Your feedback on the Northwestern path upgrade proposal

We are proposing to improve the Northwestern Path by separating the shared path at the Eden Terrace/Kingsland section into a separate cycle path and footpath. We consulted on this proposal from 27 September to 31 October 2019 and received submissions from 396 people.

Auckland Transport propose to separate the shared path at the Eden Terrace/Kingsland section into a separate cycle path and footpath. This upgrade will occur over an 850 metre stretch of the path between Central Road and Haslett Street.

Attachment 1: Proposed designs

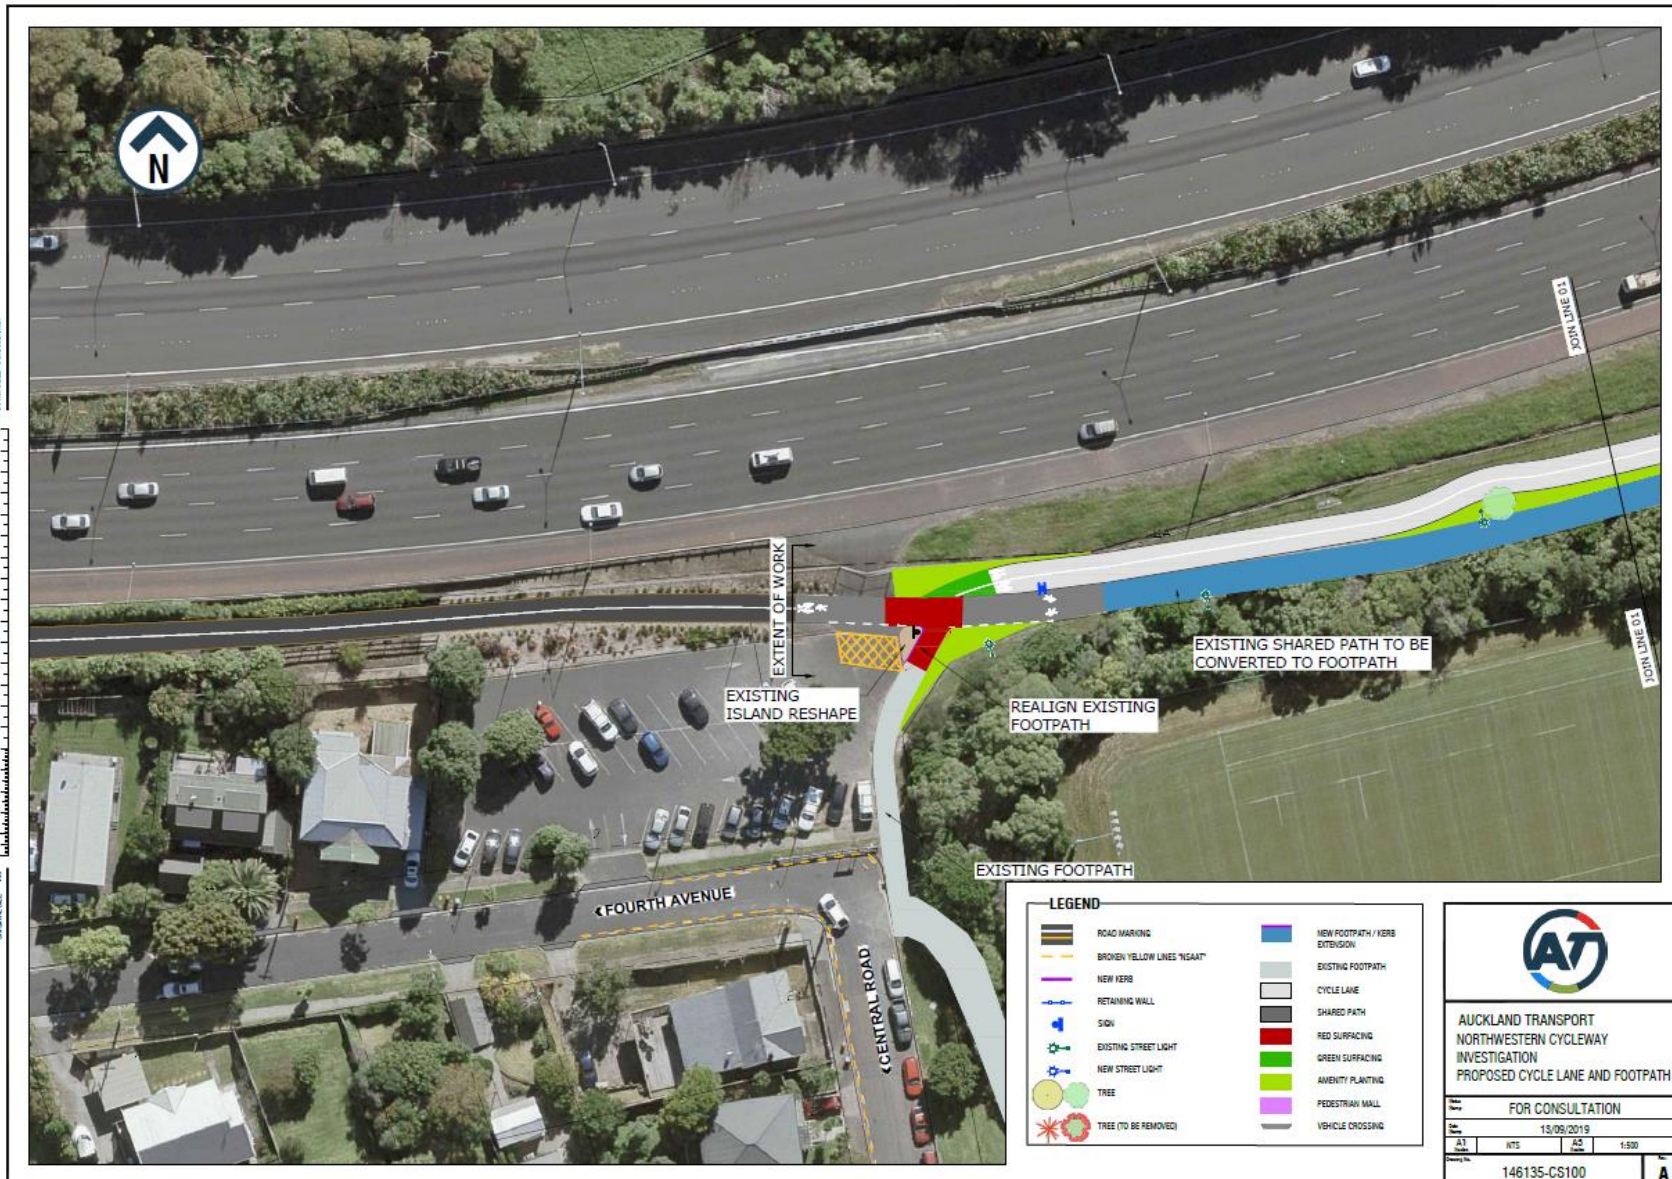
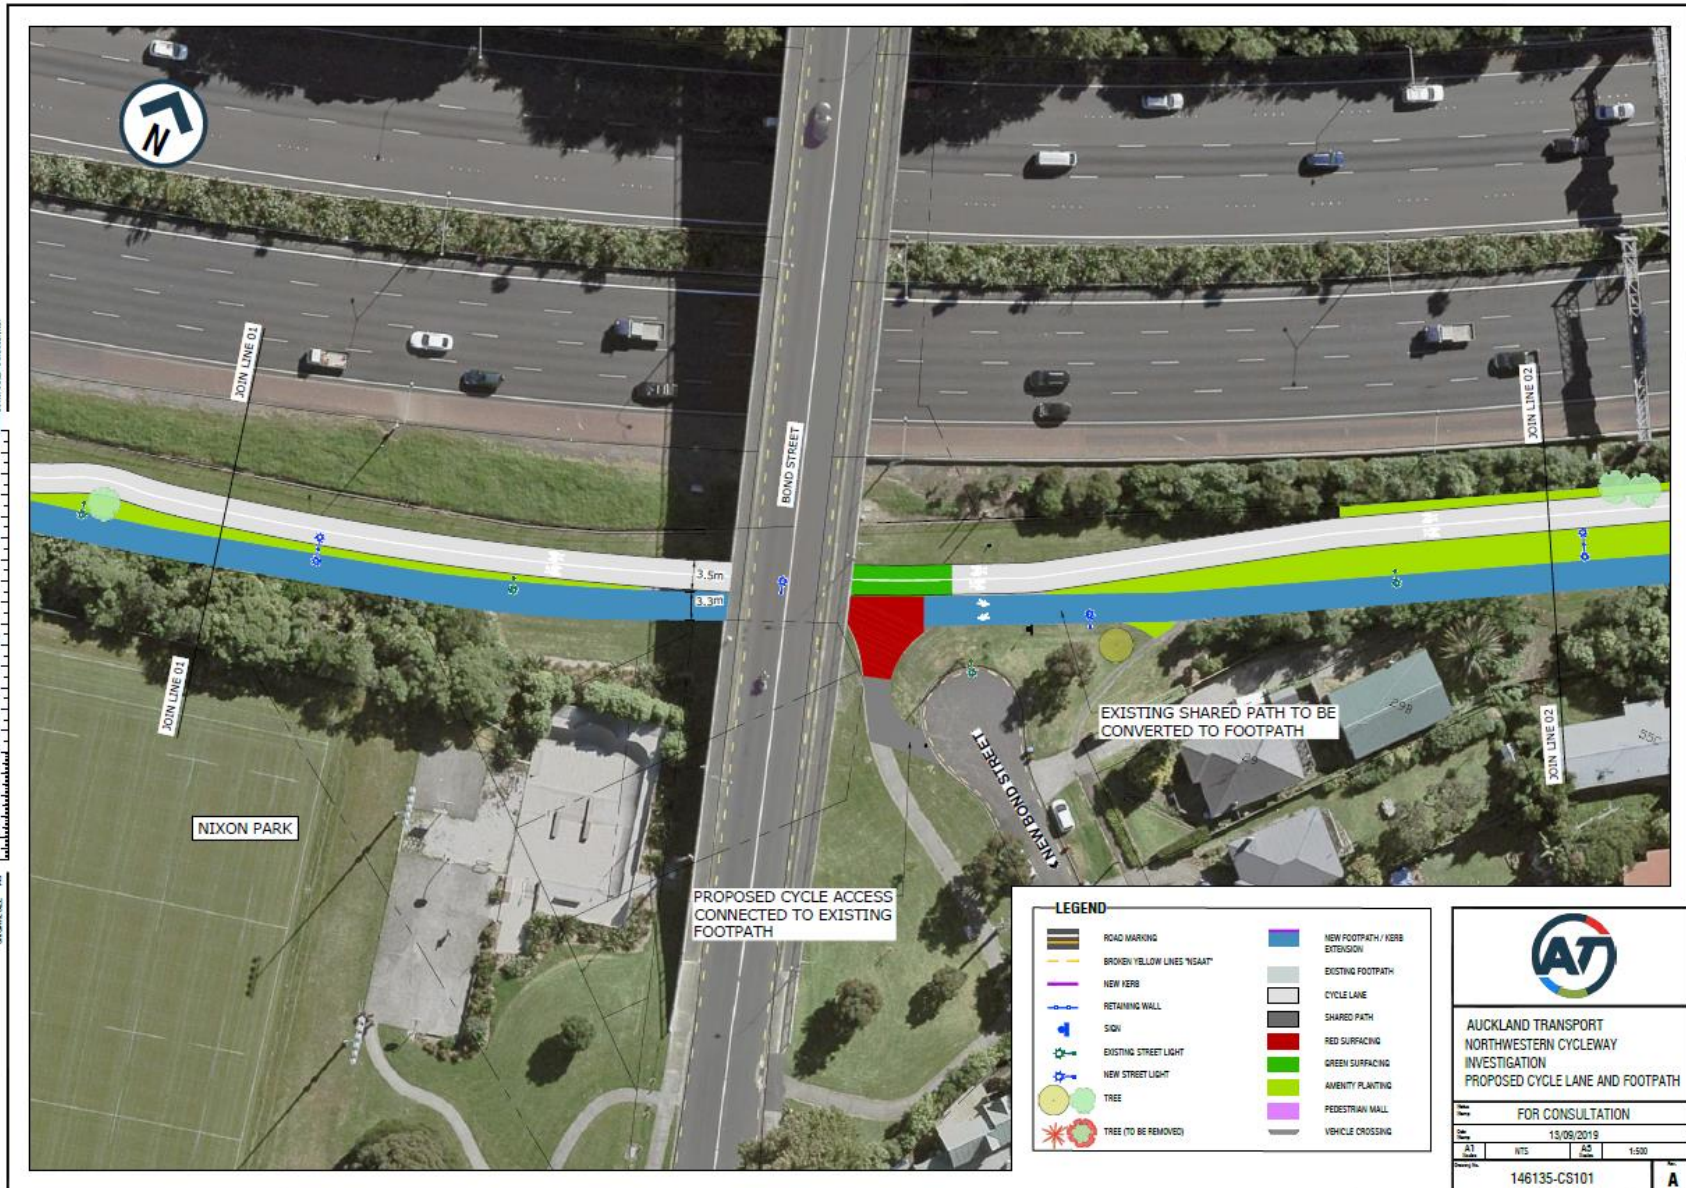
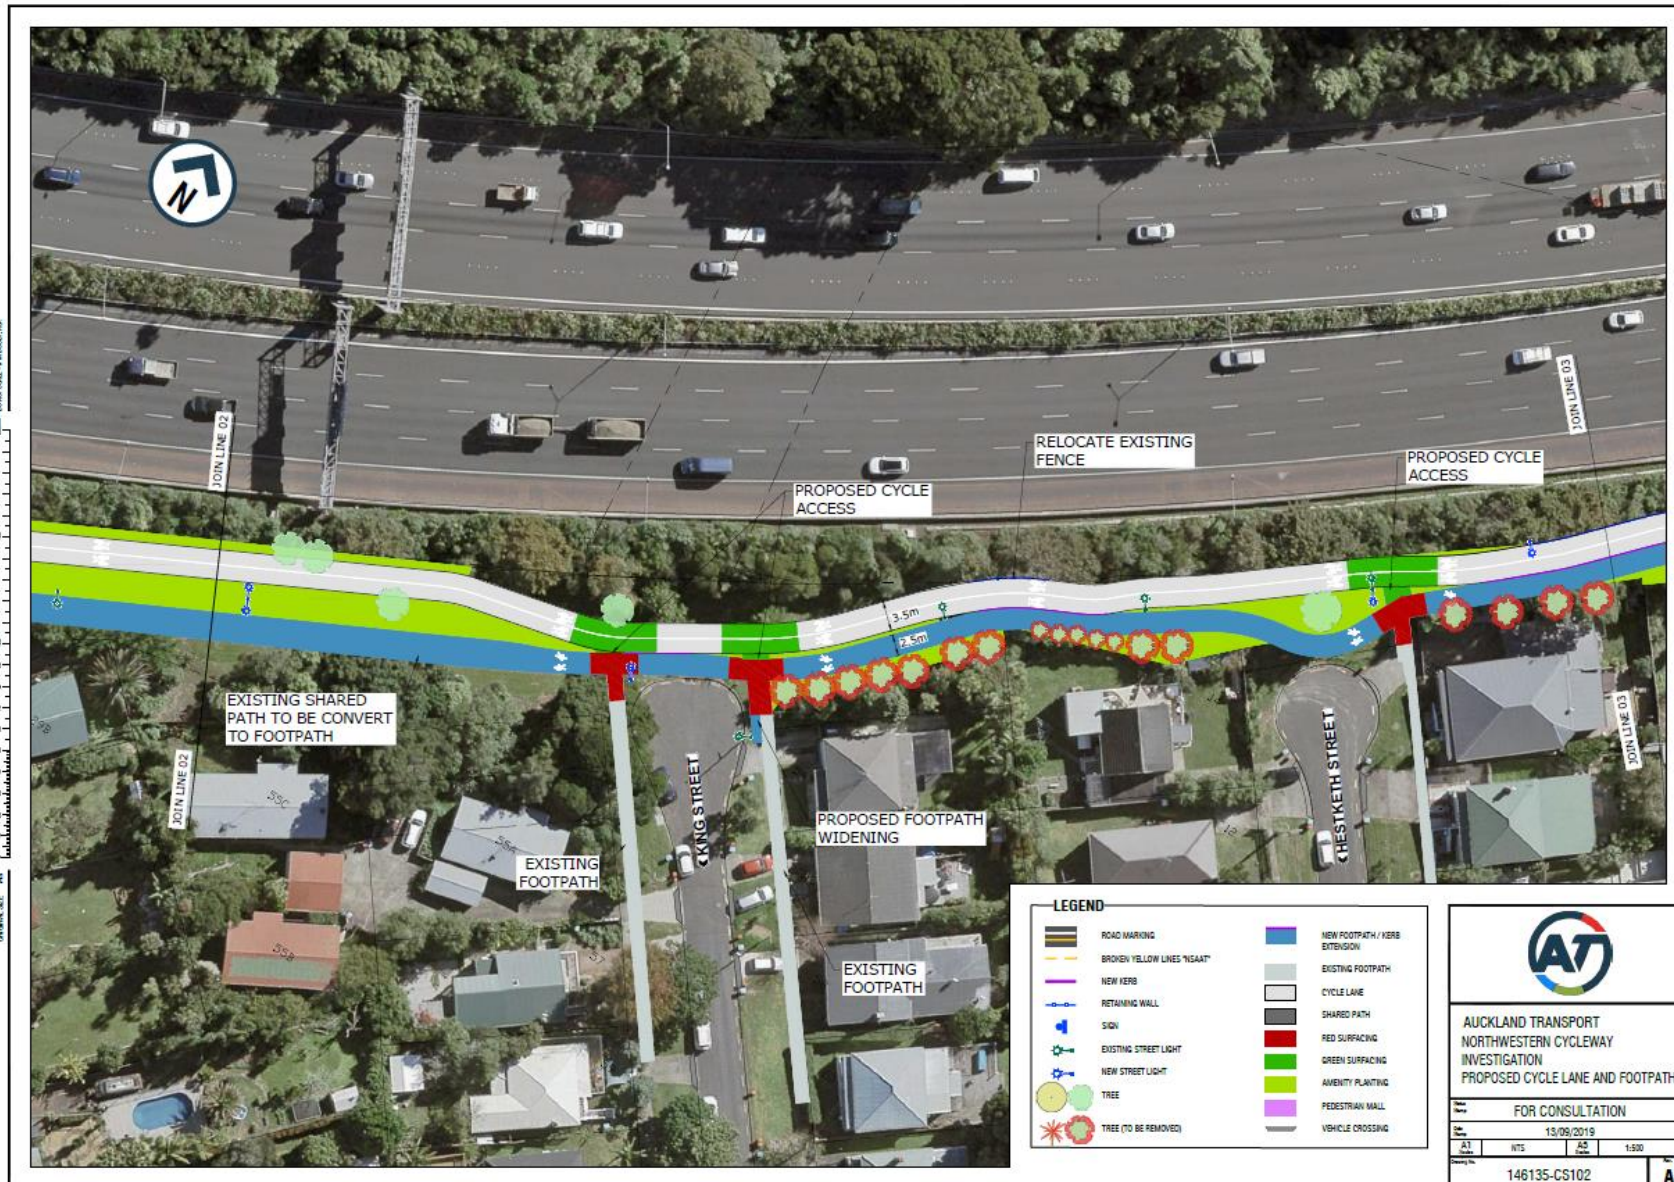
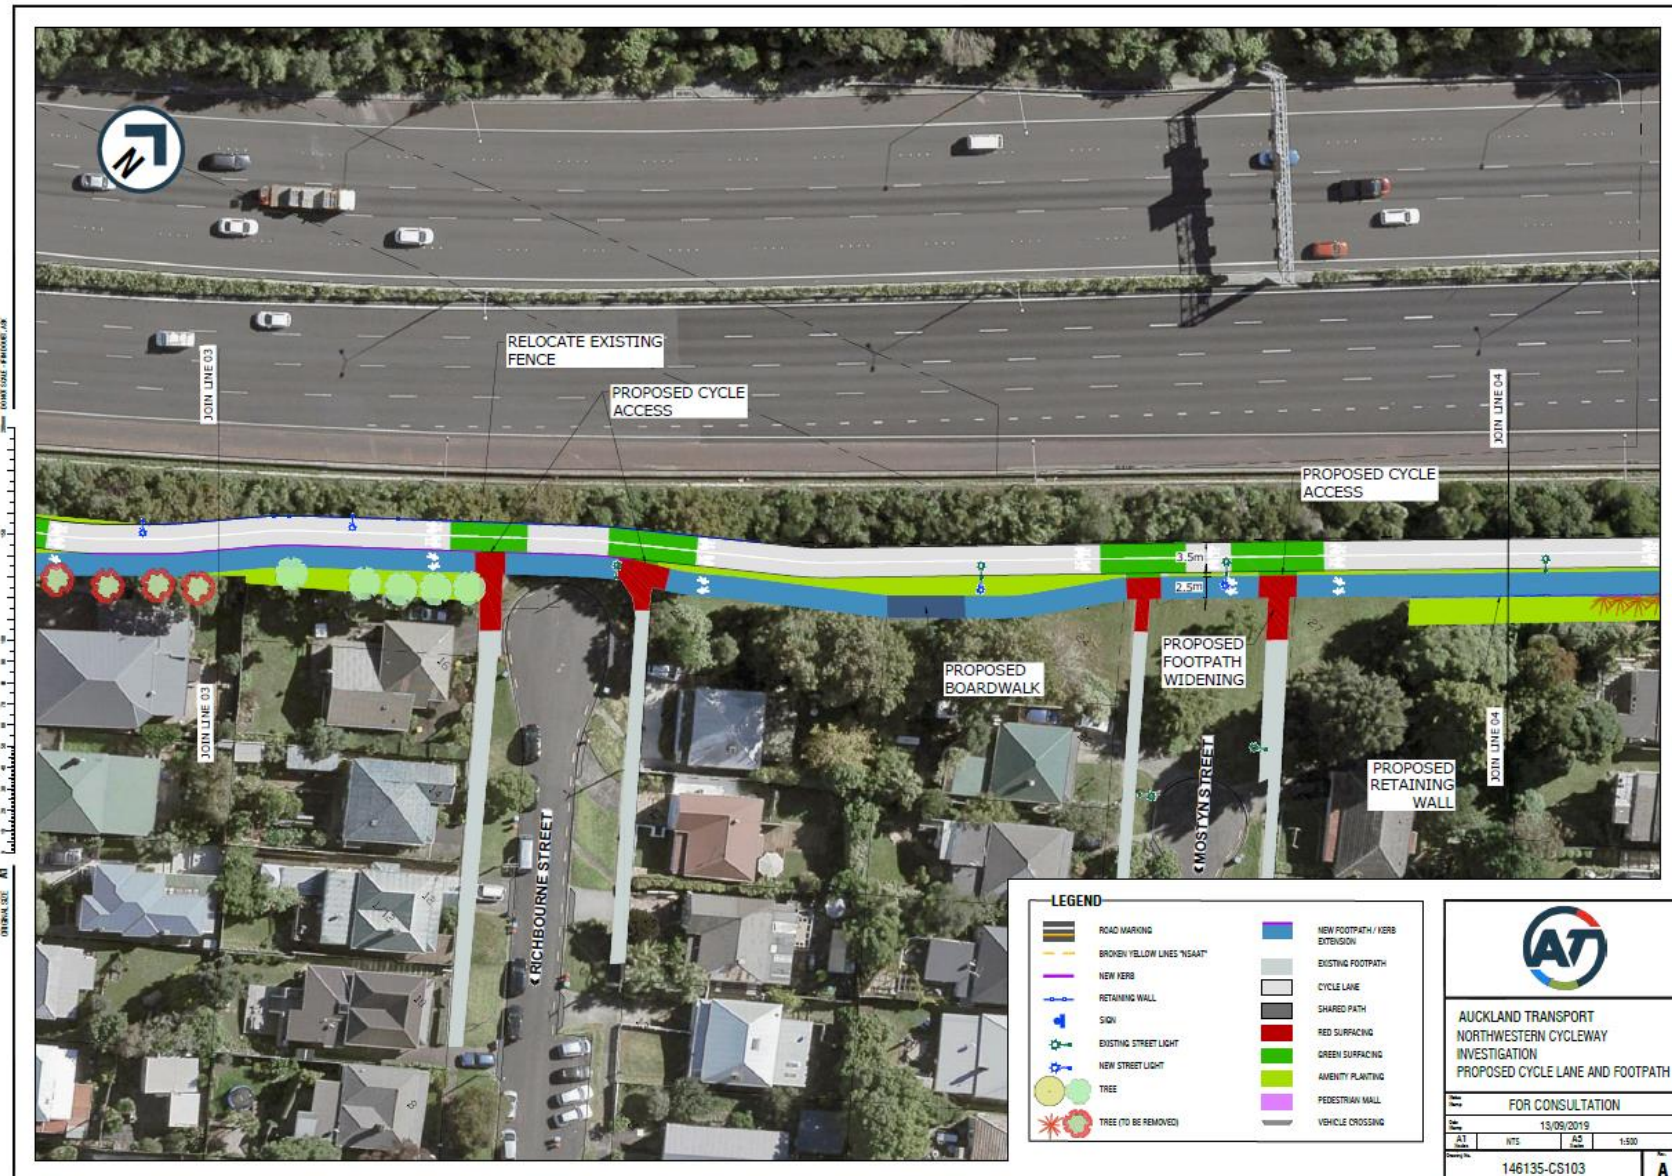
“Please review removing the small second reverse curve in the bike path between King Street and Hesketh Street (created by the proposed eastern streetlight placement).”

“Is it possible to make the interface at the western end safer? For example, it looks like the eastbound cycle lane could be moved further to the north, to create more distance between them and pedestrians.”

- please review removing the small second reverse curve in the bike path between King Street and Hesketh Street (created by the proposed eastern streetlight placement). Consider side street lights or similar here to avoid an even more "wiggly" cross-section through this part.

- similarly, consider whether the small reverse curve just east of Hesketh Street can also be straightened out. Finally, while we understand the financial / business case process reasons for leaving the Takau Street section out of this project, we would like to see works to improve the path through this section too (one of the two last on-street sections left on the Northwestern Cycleway).

Design suggestion in feedback	AT response
<ul style="list-style-type: none"> • The curvy section of the proposed cycleway opposite to King Street should be straightened to improve visibility and safety • The path should be wider to accommodate increased use in the future • The path should be wider to allow faster cyclists to safely overtake slower cyclists and pedestrians • AT's priority should be trying to make the full length of path as wide as it can be. Not just limited sections of it. • The bike path should be wider than the pedestrian path as pedestrians aren't going to crash into each other • If the pedestrian path is not straight and logical pedestrians might not use it 	<ul style="list-style-type: none"> - Where possible we are designing the path to be straight, however in some cases there are restraints that the paths will have to curve around. - The paths make the most of the width at the sections that have the least width available for the paths. Making the paths wider would create inconsistent widths along the paths. - The cycle path will be wide enough to allow faster cyclists to safely pass slower cyclists. - This section of the Northwestern Path is the second busiest cycleway in Auckland and there are conflicts regularly occurring between cyclists and pedestrians. The proposed improvements will help alleviate this issue and allow for further growth in active modes along this section of the Northwestern Path. - The footpath still needs to cater for large groups of users at the same time such as school children, walking groups and mobility impaired users to safely pass each other without getting in each other's way.

Design suggestion in feedback	AT response
<ul style="list-style-type: none"> At the eastern interface, it looks like the cycle signs aren't in the right place on the road (they should be offset to the north). With the vertical alignment here, it may not be possible for westbound cyclists to see the green surfacing from further back along Takau Street 	
Who goes where?	
<p>It's unclear where children on bikes and scooters should go</p> <ul style="list-style-type: none"> The two lanes should be separated by speed rather than mode, as children riding bikes or scooters would be safest in the pedestrian lane and some fast pedestrians like runners might be more comfortable in the cycle lane The paths should be separated by speed rather than mode, so someone on a wheeled device (scooter, bike, etc) can go in the pedestrian area as long as they stay strictly at walking pace and give way to pedestrians. That may be safer and kinder to small children learning to ride to school than to insist they (and their adult caregivers) ride with full-speed adult commuters. 	<ul style="list-style-type: none"> As per NZTA guidelines, children using scooters and bikes with a wheel diameter less than 355 millimetres are allowed to ride on the footpath. It would be difficult to enforce the give way and speed restrictions on a footpath and would not be a suitable environment to ride a larger bike. There is currently no bylaw allowing cyclists on a footpath with a restriction to speed.

Lighting	
<p>Streetlights should be moved further from the path</p> <ul style="list-style-type: none"> The plan shows several existing streetlights in the middle of the cycleway, or too close to the edge of the cycleway. These should be moved to a more suitable location. 	<ul style="list-style-type: none"> The streetlight locations will be reviewed as part of detailed design.

Design suggestion in feedback	AT response
<ul style="list-style-type: none"> 42 small native trees are proposed to be removed between King Street and Richbourne Street. These trees were recently planted and are an excellent mix of species so ideally those close to the boundary should be retained 	
<p>AT should not remove any of the any screen planting between the path and the motorway</p>	<p>Species and extent of plants installed or removed will be decided upon in detailed design and these points will be taken into account.</p>
<p>Invasive exotic species, especially Tree Privet should be removed</p> <ul style="list-style-type: none"> The invasion by tree privet is extensive on the NZTA side of the fence opposite the planned upgrade. It is replacing the native planting and starting to interfere with the form of the mature oaks there. It will continue to spread, and dominate further, if it is not controlled. Auckland Council has recently adopted an Urban Ngahere (Forest) Strategy which seeks to increase tree cover in the city from 18% to 30%. As a CCO, Auckland Transport has a responsibility to make up for the removal of existing trees by planting new ones nearby and protecting those that currently exist from invasion by weed species. 	<ul style="list-style-type: none"> This feedback will be passed onto NZTA for consideration Species and extent of plants installed or removed will be decided upon in detailed design and these points will be taken into account.

The layout of the path should be altered <ul style="list-style-type: none"> • At the Takau Street junction, the slope under the Haslett Street bridge should be levelled out to eliminate the current blind rise 	- We are looking into design options to maximise visibility and reduce speeds where Takau Street meets the Northwestern Path.
